## VEAY LLO Existing Cable Piers Locations

Existing layout

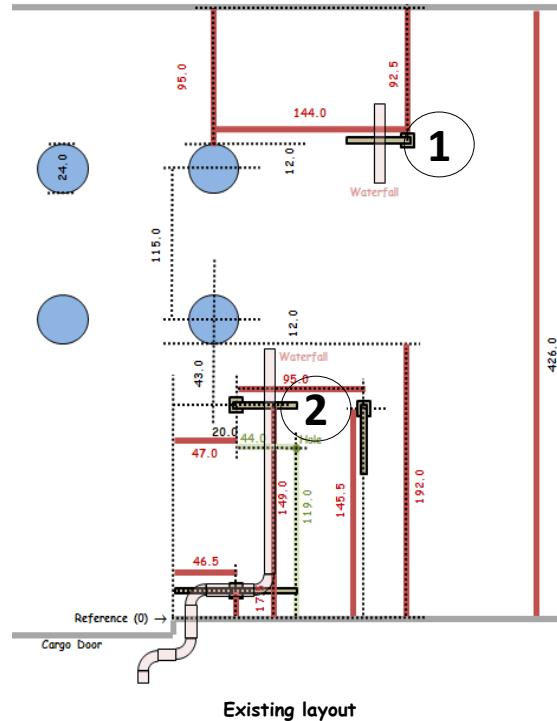
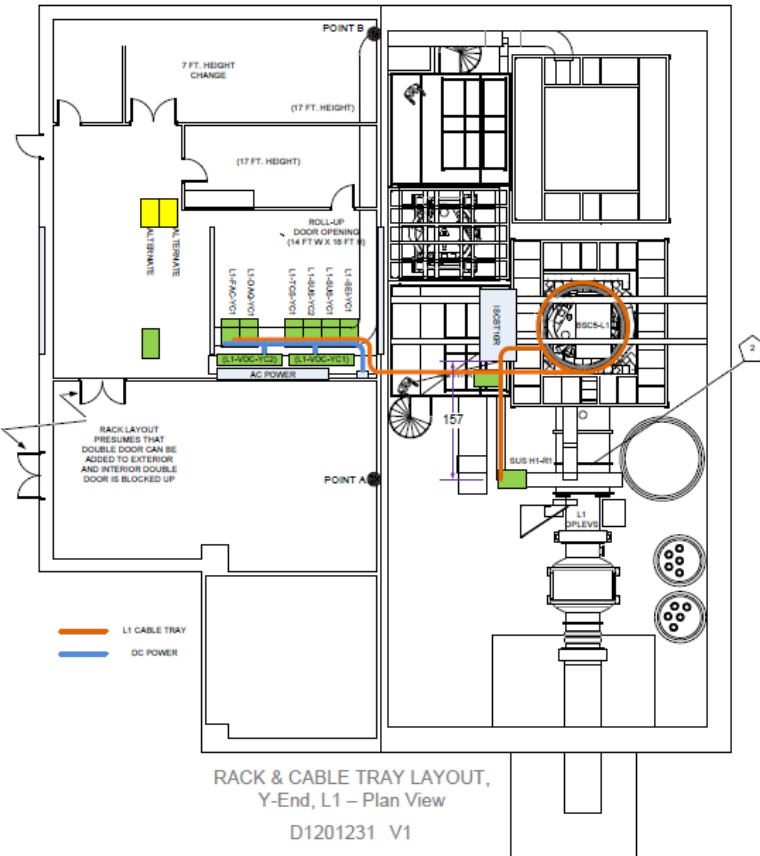
**Questions and comments:**

- 1) Where does 11U Short Rack (D1001423-v11) go? (Ignore)
- 2) Where does L1-AOS-YR1 (if it needs to exist) go? (Does not exist)
- 3) What does pentagon-2 mean regarding tray removal? Is there tray across the beam tube from L1-SUS-YR1? (Ignore)
- 4) Is the called-out 10' height important for some reason? LLO height is 8'. (OK)
- 5) What are the double doors in the note all about? (Ignore)
- 6) A door is missing from the garb room to the VEA. (Ignore)
- 7) The doors are missing from the mechanical room. (Ignore)
- 8) L1-VAC-YR1 is missing. (Shown)
- 9) All cabling that currently uses under-beam tray and the waterfall is missing. (Kurt)
- 10) The Photon Calibrator is missing. (Mounted to tube - part of OPLEV)
- 11) VE Pumps are not shown. (Shown)
- 12) Size of ISCB5R is not specified. (72 x 48)

New layout

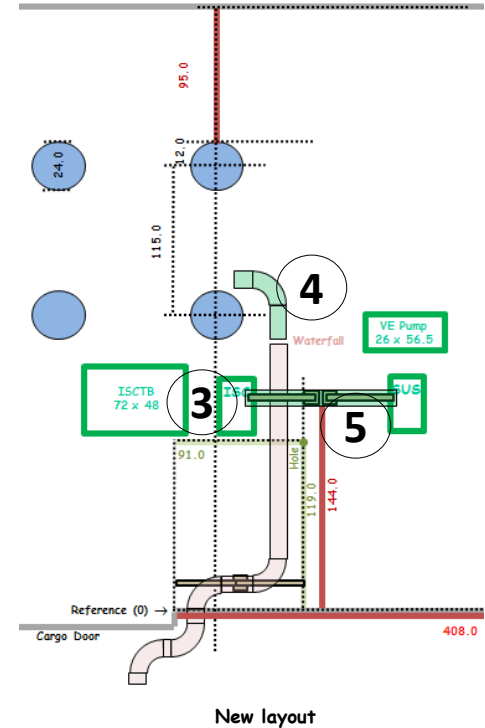
**Things that can be done: (Note: Green trace is new tray.)**

- 1) Remove old cable tray and pier that interferes with dome parking.
- 2) Relocate existing piers to support cable tray to L1-SUS-YR1.
- 3) Locate L1-ISC-YR1 farther away from existing pier for clearance.
- 4) Suggest joining basket around BSC to existing cable tray at waterfall.
- 5) Add cable tray to reach L1-SUS-YR1.

It is 65' from the L1-FAC-YC1 Rack to the knee of the waterfall in the VEAY.  
The height of the cable trays is 8'.
